NRW response – Cwmwernderi – Secondary 23/02/22

NRW response – Cwmwernderi – Initial 19/01/22

Figure 3 Bat house location

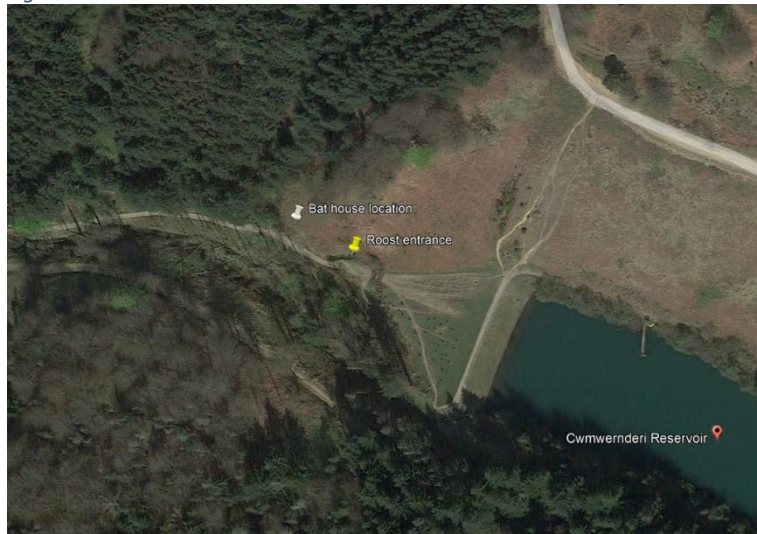
- *In addition, we previously asked for a description of the habitat surrounding the proposed location of the bat house, which hasn't been provided. This is required to ensure suitable habitat and flight lines are present around the structure and therefore should be submitted in support of the application. We included this information in our original response. **"The bat house will be located approximately 35m from the existing roost entrance at the bottom of a deep shaded valley. The surrounding habitat comprises plantation woodland, scrub, grassland and a watercourse (to the south)."** There is also a small stream the runs immediately to west of the proposed location that runs into the main watercourse to the south. Please see the plan and photographs below.*
